ADDENDUM NUMBER 01 TO THE BID DOCUMENTS

BID DOCUMENT: 17/18 MB7
121 -35617 - Organic Farm Classrooms
College of Marin – Indian Valley Campus

Addendum Date: 20 February 2018

OVERALL SITE PLAN

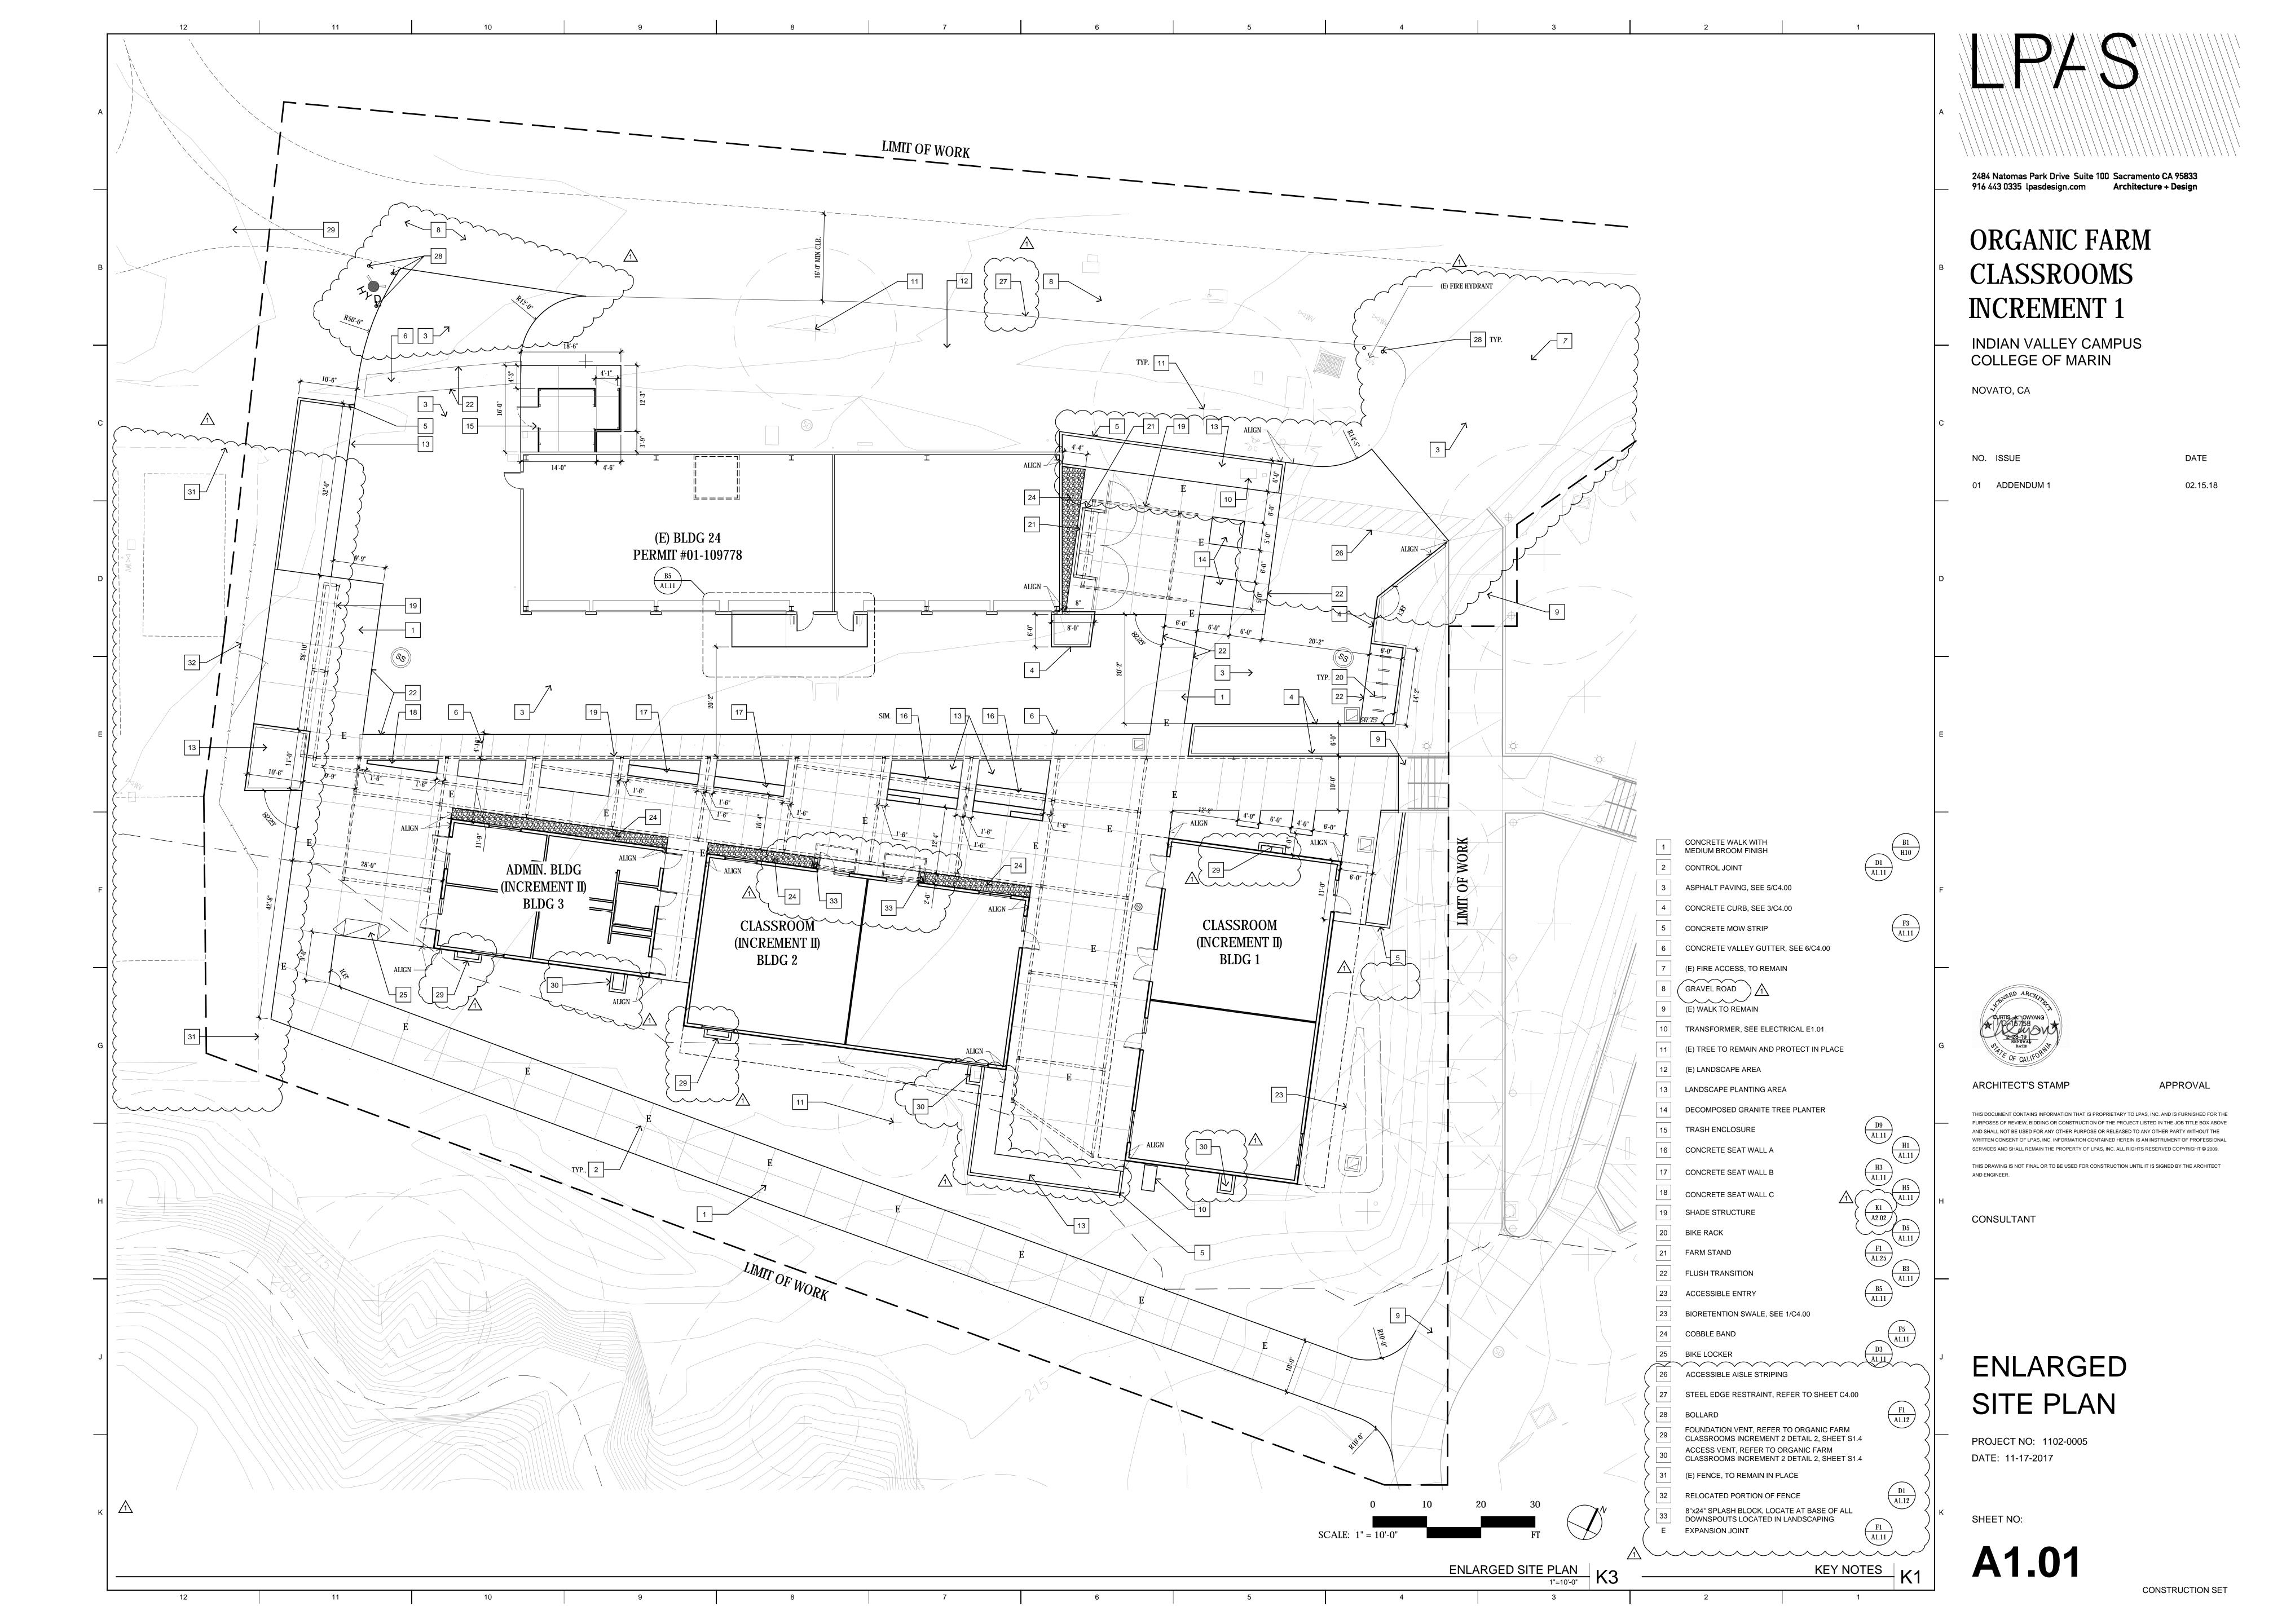
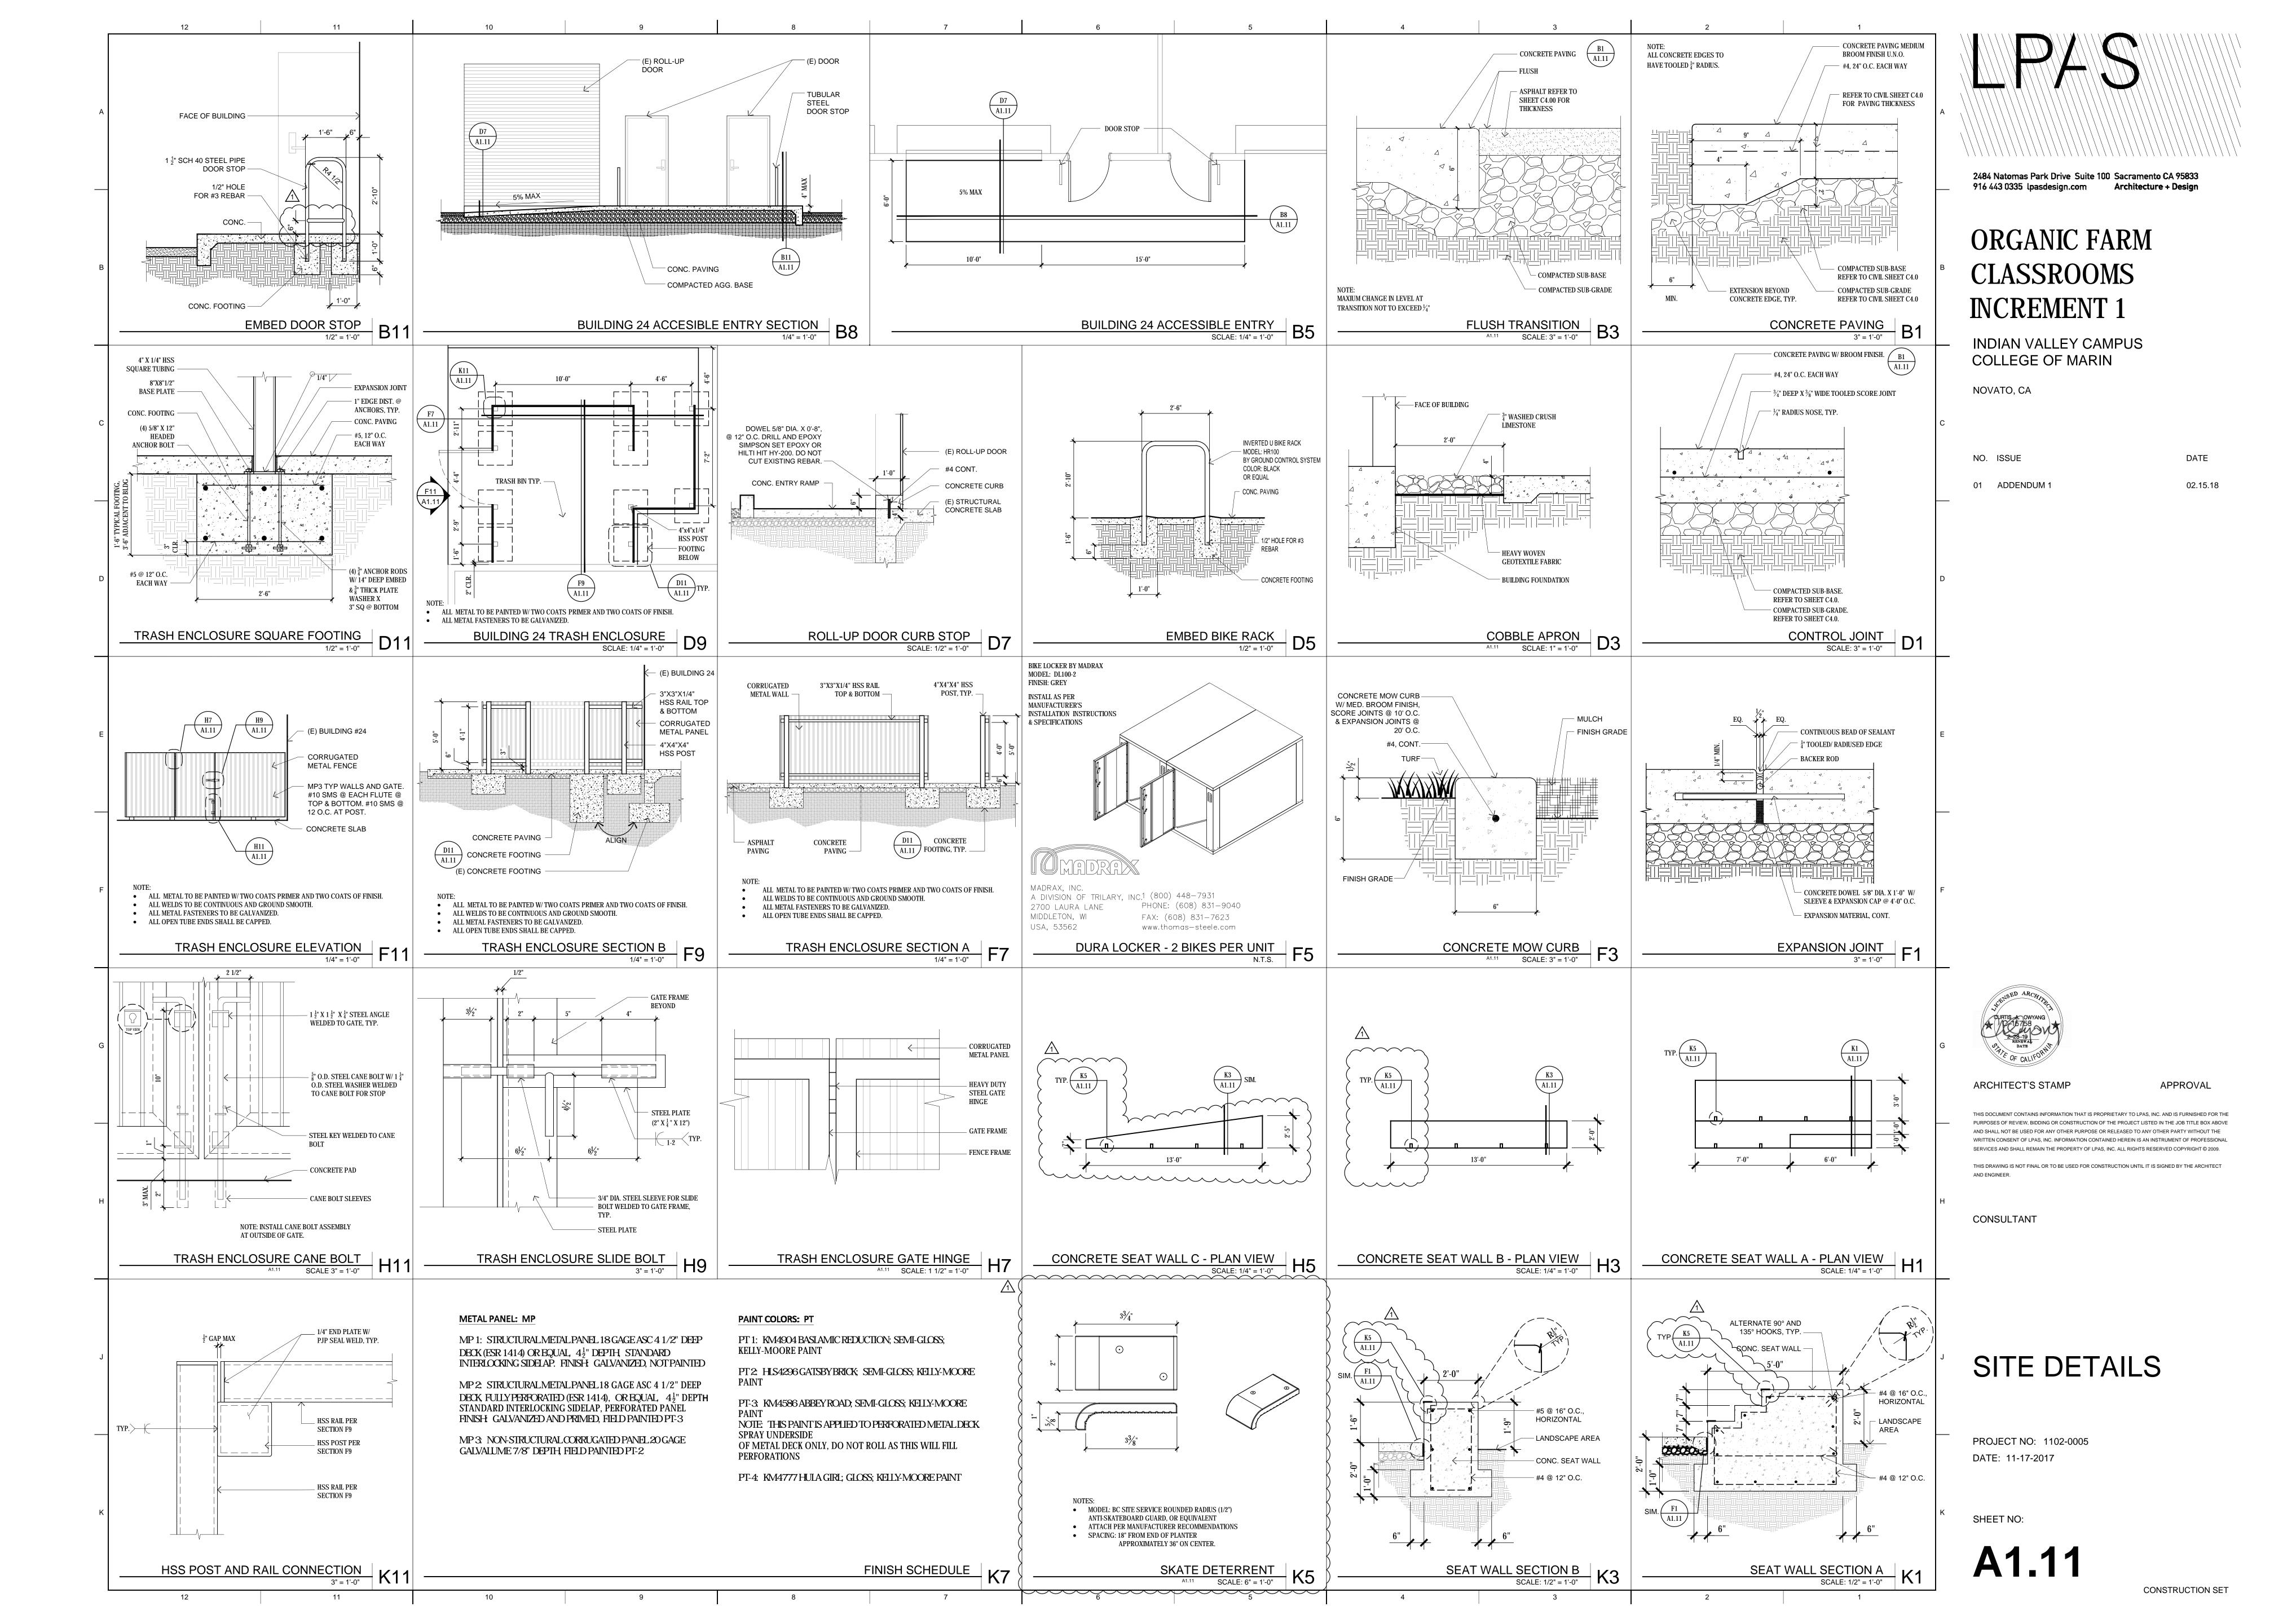
A1.00 Overall Site Plan (Replacement sheet)

Updated area of Scope of Work, existing Greenhouse, Shade Structure, Sea Crate and fencing to remain.
